From: Pederson Ronda M (AREVA NP INC) [Ronda.Pederson@areva.com]
Sent: Monday, July 13, 2009 6:04 PM
To: Tesfaye, Getachew
Cc: BENNETT Kathy A (OFR) (AREVA NP INC); DELANO Karen V (AREVA NP INC); NOXON David B (AREVA NP INC)
Subject: Response to U.S. EPR Design Certification Application RAI No. 234, FSARCh. 19 (Part 1 of 4)
Attachments: RAI 234 Response US EPR DC (Part 1 of 4).pdf

Request for Additional Information No. 234

U. S. EPR Standard Design Certification

SRP Section: 19 - Probabilistic Risk Assessment and Severe Accident Evaluation

Figure 19-307-2—Concrete Hoop Stress (S_y) in Cylinder

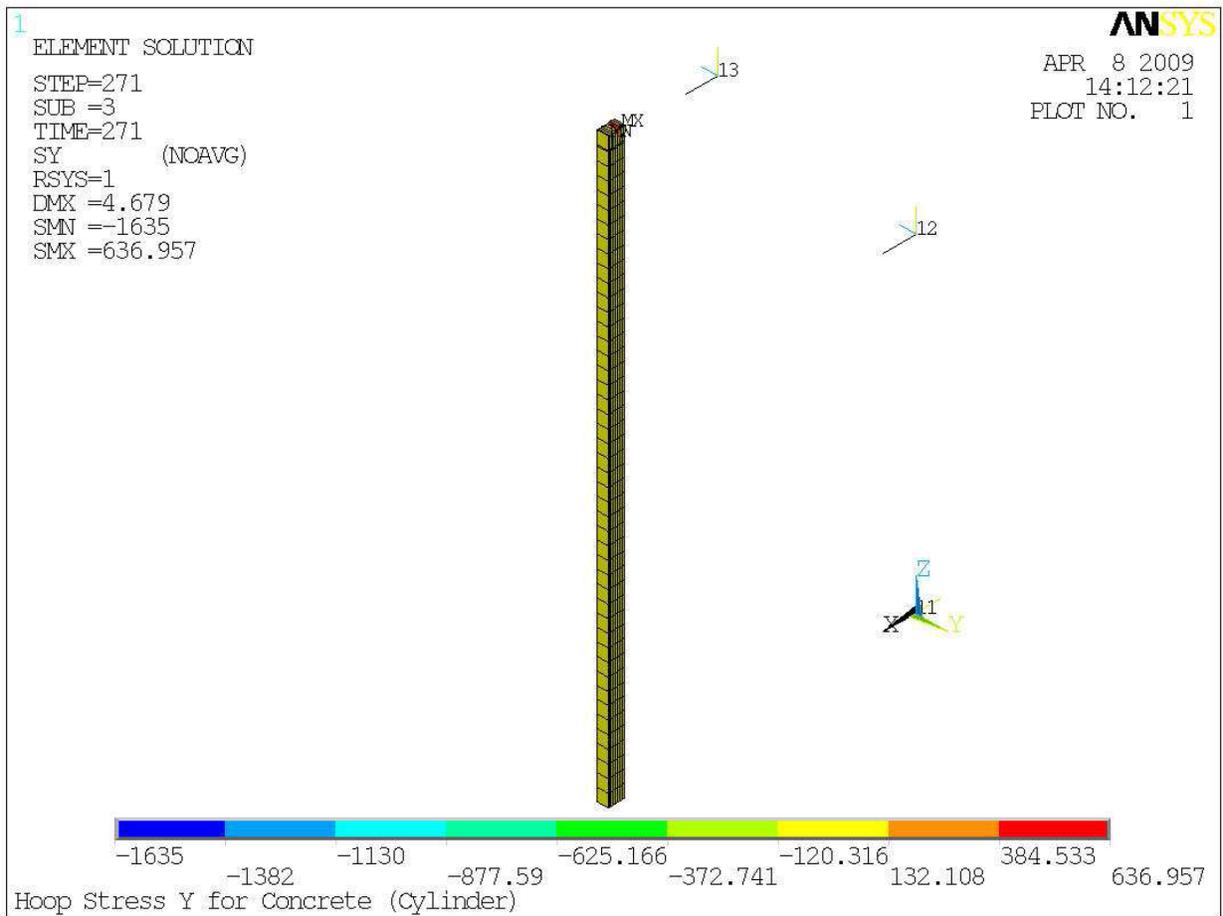
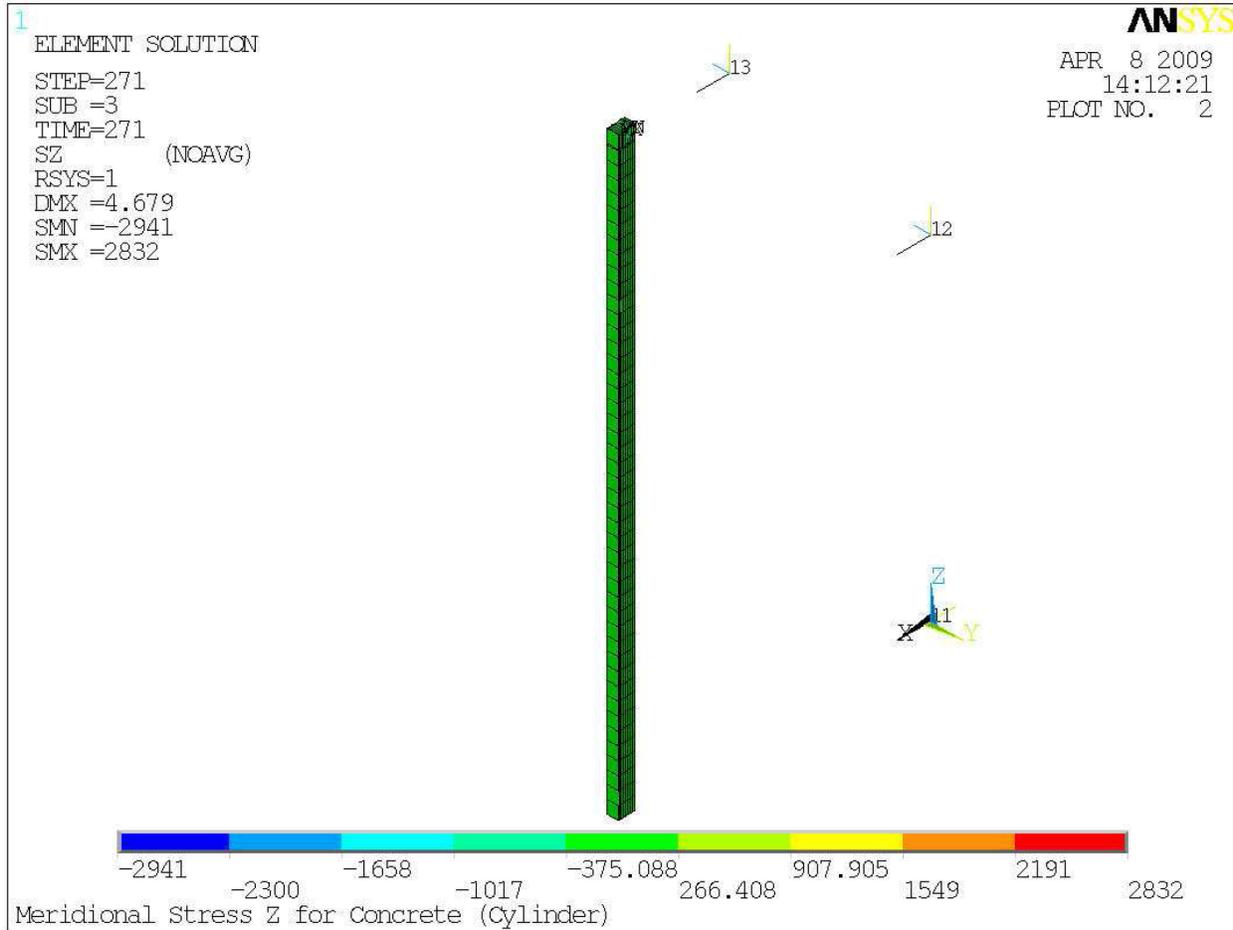
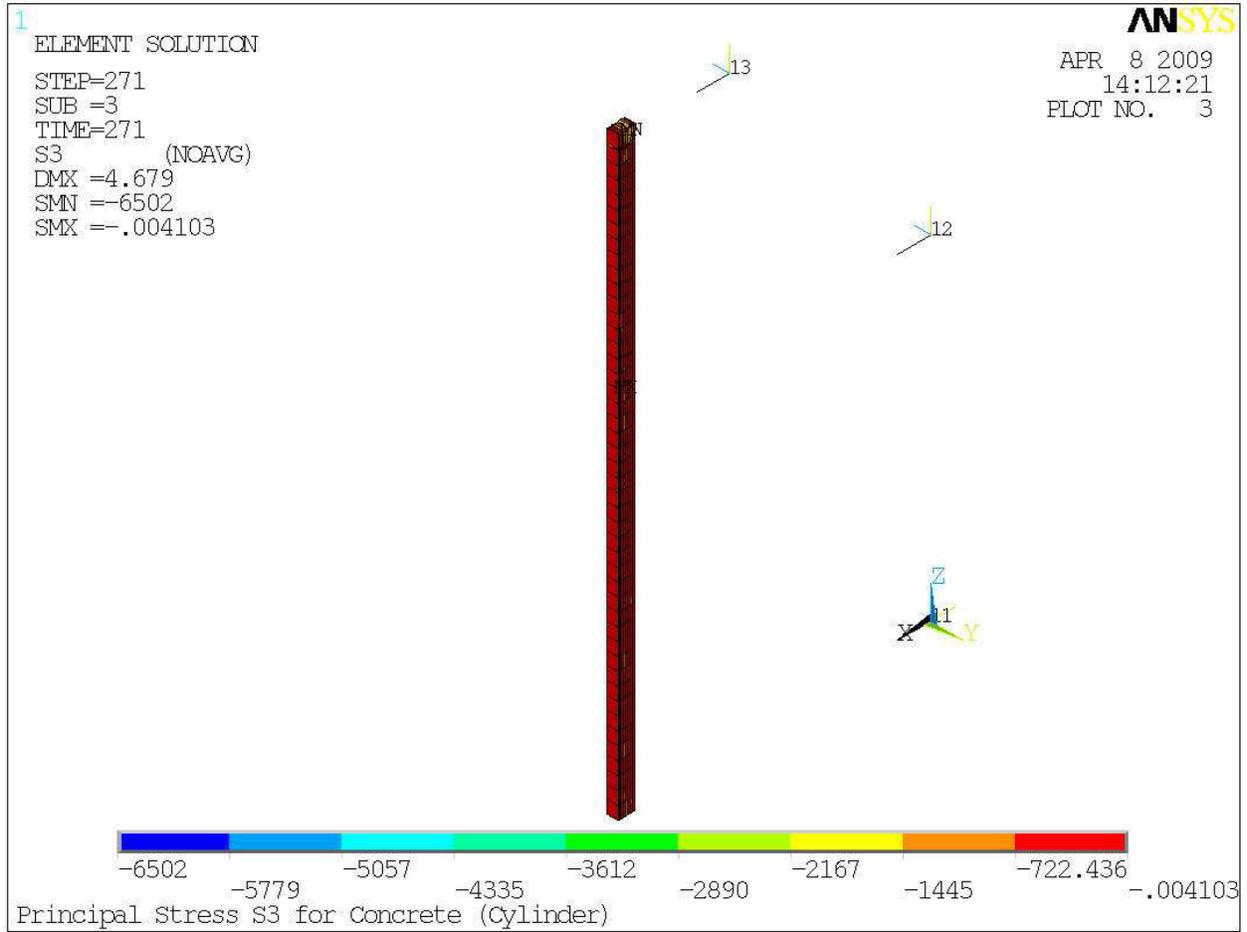
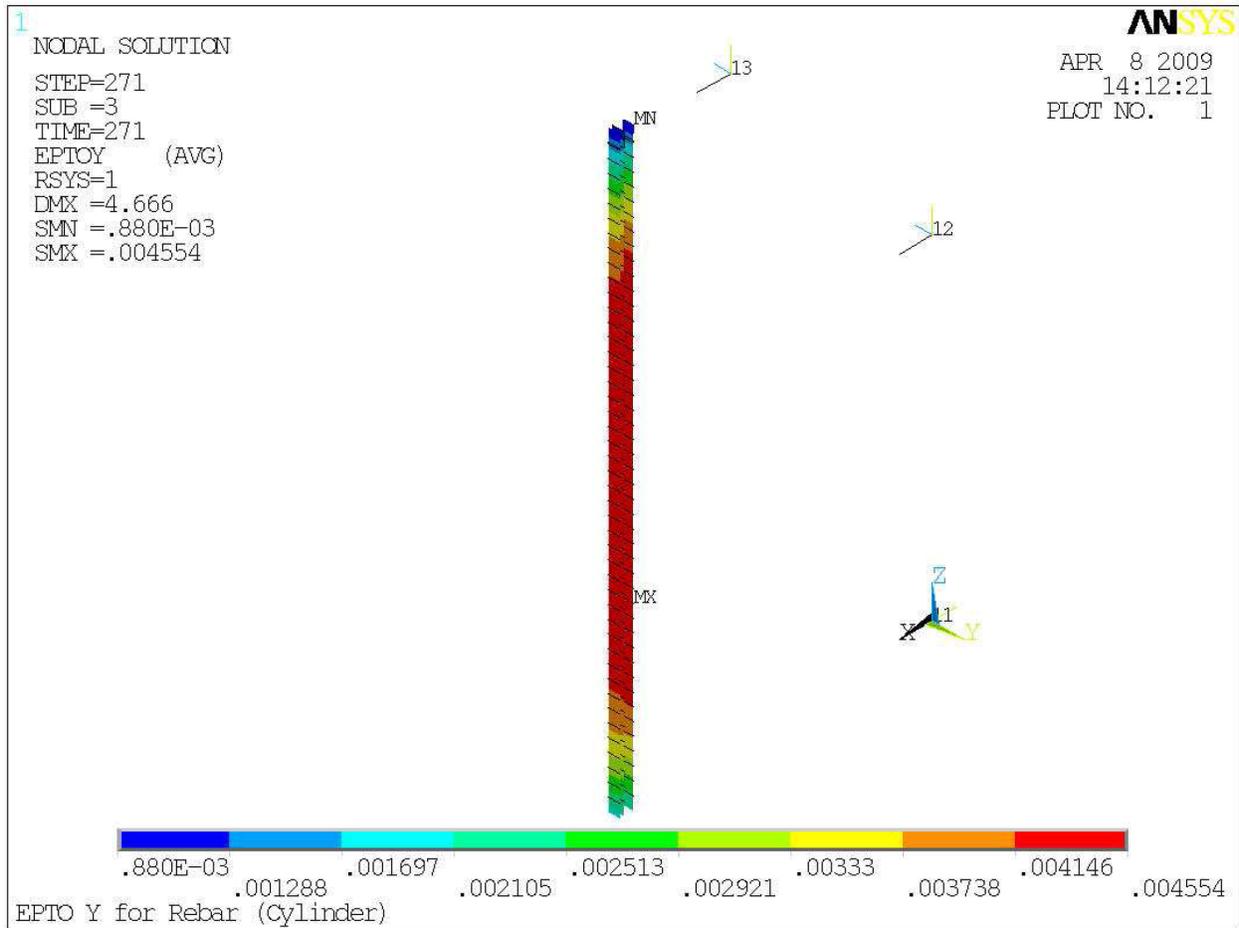
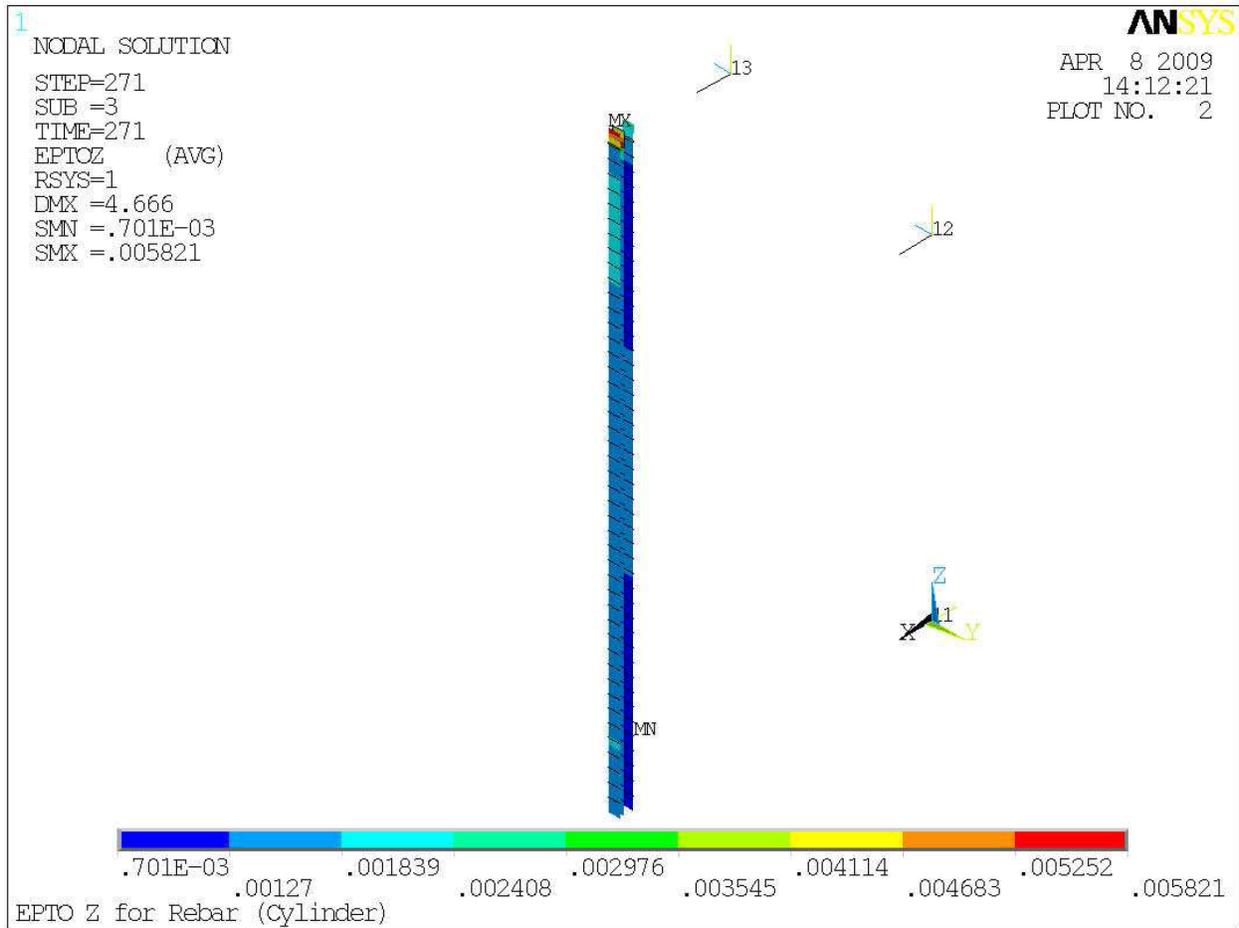
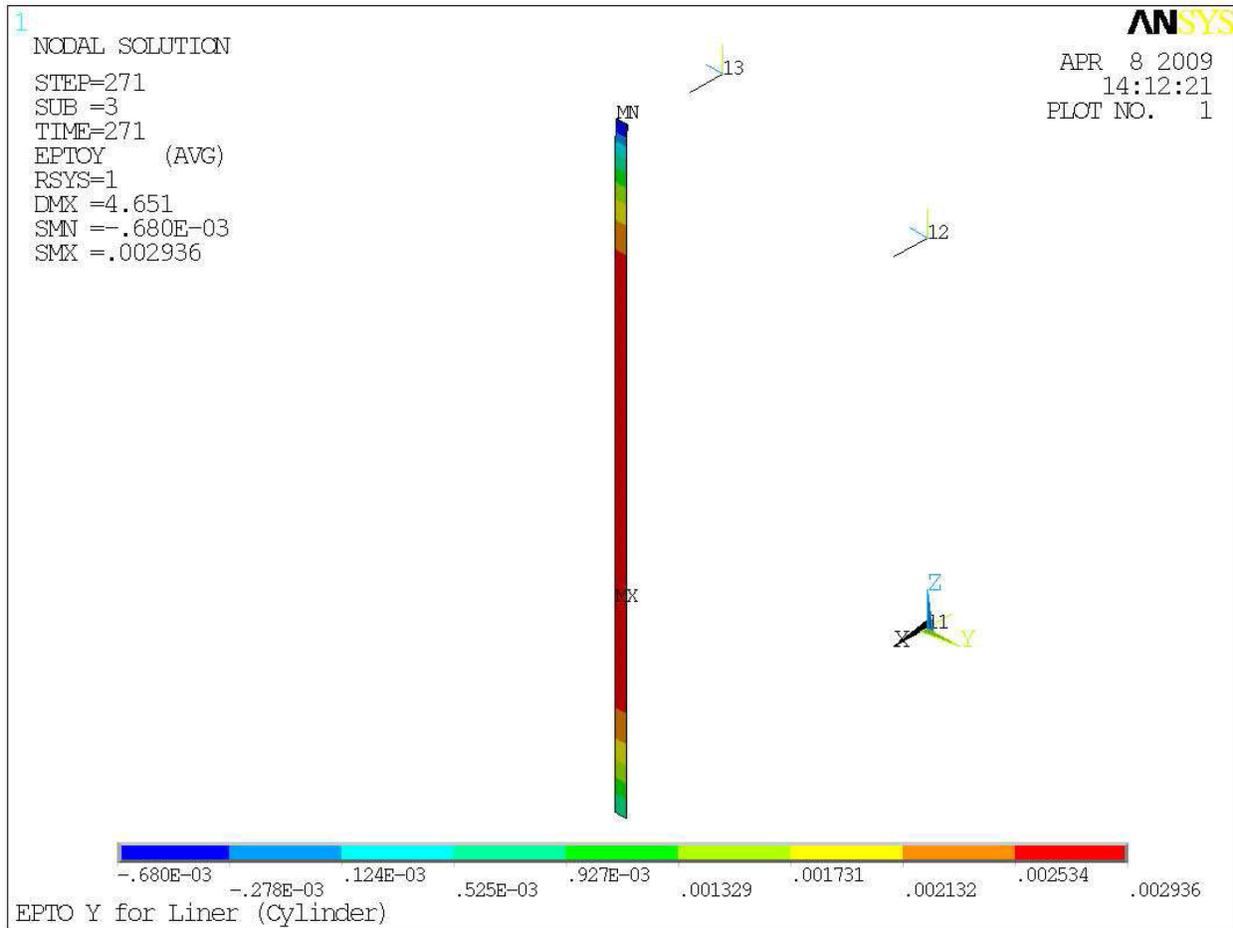
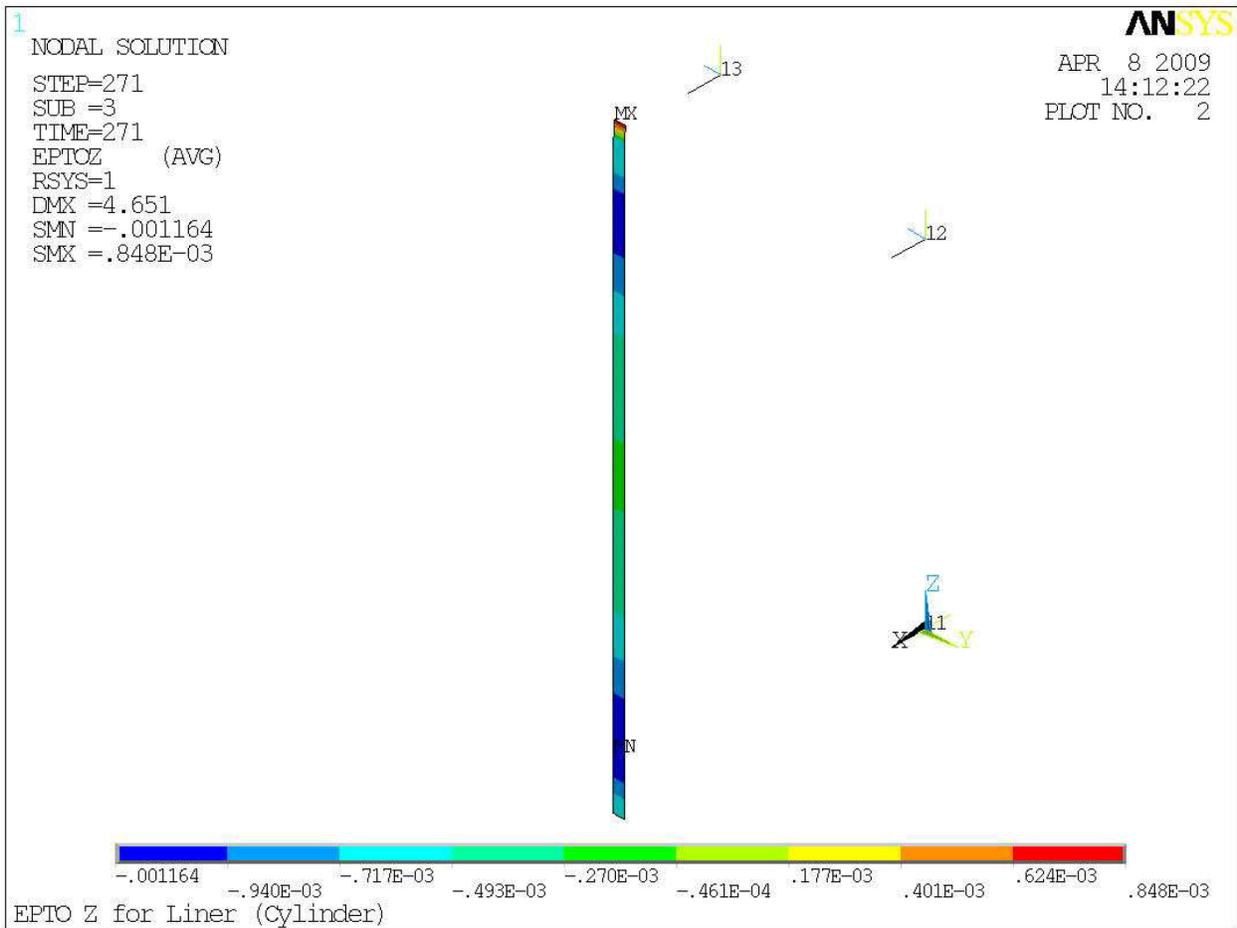
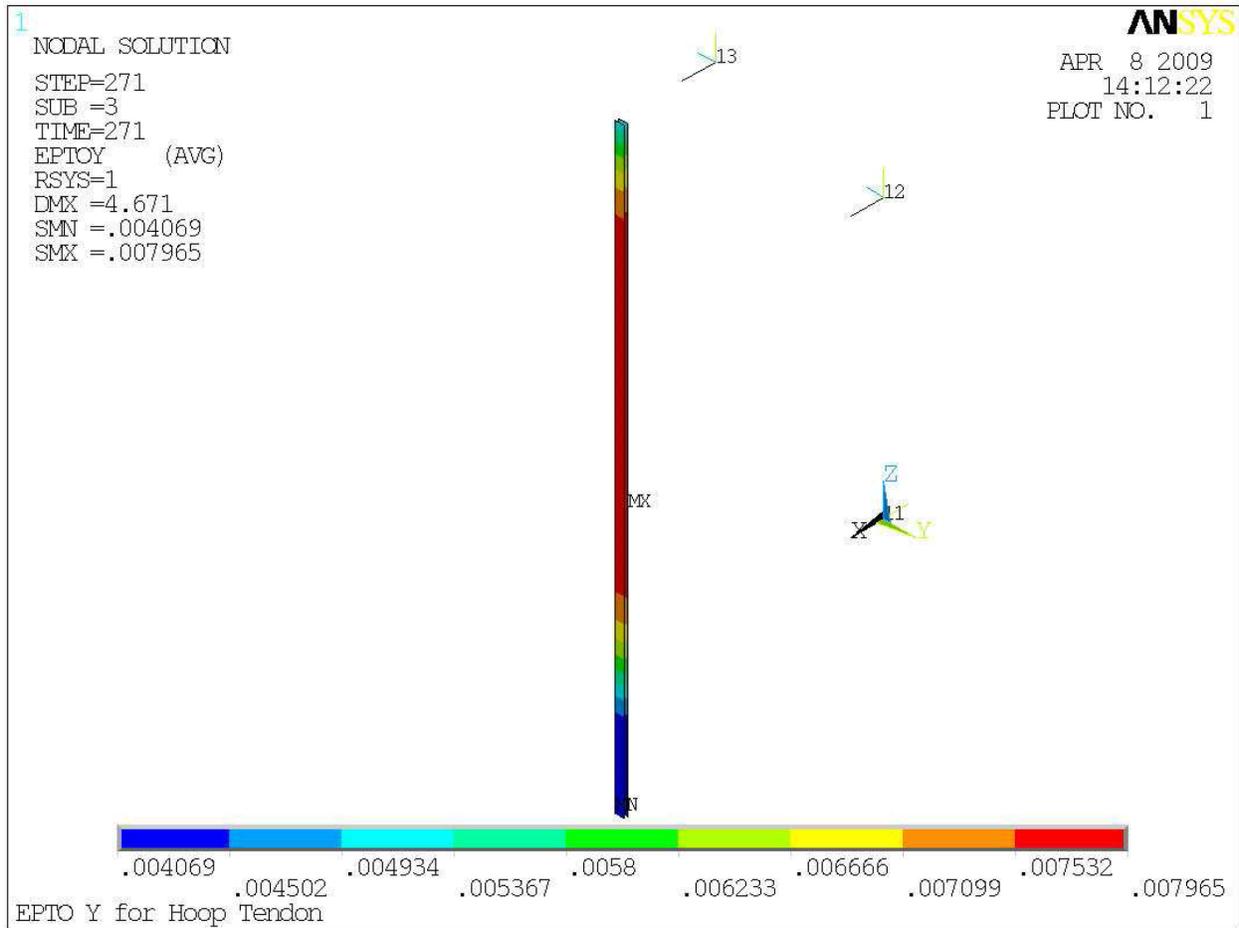
- a) The containment pressure fragility should be determined based on analyses which utilize appropriate material constitutive relations, and an assessment of uncertainties within a probabilistic framework. The uncertainties in the analysis results should be associated with the modeling and analysis approach (epistemic uncertainty), the material properties (aleatoric uncertainty) of the structure at the time of the accident, failure criteria or limit states used in establishing the pressure capacity, and the loading conditions that lead to pressurization of the containment.

- b) Failure criteria are defined to establish limit states on the structural response where the internal pressure is no longer contained by the structure. Uncertainty in defining these failure criteria should be addressed; one could use median and 95% confidence values to evaluate the effect of the uncertainty on the analysis results.

From the finite element analysis results the ultimate pressure capacity for a typical zone of the dome is $P_u = 267$ psig, which is based on the deterministic approach estimating the ultimate capacity of a pre-stressed concrete containment. Since the median material strength is higher than the guaranteed material strength used in the deterministic approach, it is expected that the median pressure capacity ($P_m = 297$ psig) calculated using the median stresses is found to be higher than that ($P_u = 267$ psig) determined by the finite element analysis. The results of finite element analysis for the cylinder wall are shown in Figures 19-307-2 through 19-307-10. These plots show an ultimate pressure capacity of 267 psig at time step 271, corresponding to a strain criteria of approximately 0.8 percent..
